## RECALL 24V803 REMEDY INSTRUCTIONS

<b>FOREST RIVER</b>	Make(s): PALOMINO Model(s): PAT2085BHS Model Year(s): 2025	Repair Code: RC-026-13-00-004624 Allotted Time: .50 HRS. Inspection Code: N/A Allotted Time: N/A
	Concern: The LP Gas manifold block may be installed in the jounce path of the axles' equalizer.	Photo(s) Required: NO Prior Authorization Required: YES Part(s) Kit Number: N/A Part(s) Return: N/A

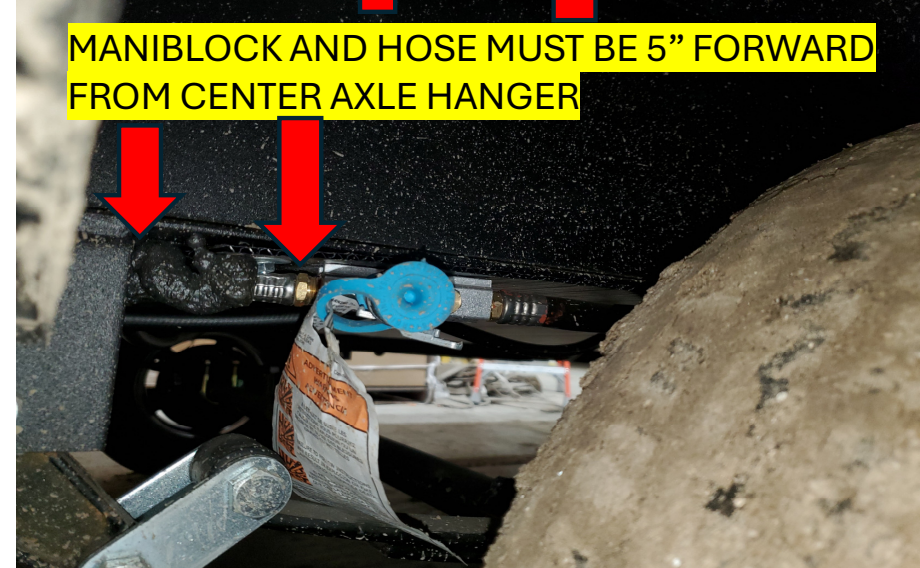
PICTURES TO THE RIGHT ARE THE REPAIR EXAMPLES GAS LINE, MANIBLOCK AND RVQ-DISCONNECT MUST BE 5" FORWARD FROM CENTER AXLE HANGER TO PROVIDE ENOUGH CLEARANCE FROM EQUALIZER FAILURE TO DO SO MAY RESULT IN 1 OR MORE OF THE GAS LINE PARTS TO BE CRUSHED

MANIBLOCK AND HOSE MUST BE 5" FORWARD FROM CENTER AXLE HANGER

PICTURE BELOW SHOWS THE EQUALIZER BEING BELOW THE GAS LINE WHEN GOING OVER A CURB OR POTHOLE IT MAY CAUSE IT TO CRUSH THE GASLINE

STEP 1: LOCATE THE LPG MANIFOLD WITH QUICK DISCONNECT NEXT TO THE CENTER AXLE HANGER;

STEP 2: REMOVE FASTENERS FROM LPG MANIFOLD AND MOVE THE MANIFOLD TO 5" FROM THE CENTER AXLE HANGER;

- ENSURE THE QUICK DISCONNECT IS STILL ASSESSABLE;

STEP 3: REINSTALL THE FASTENERS, OR USE NEW;
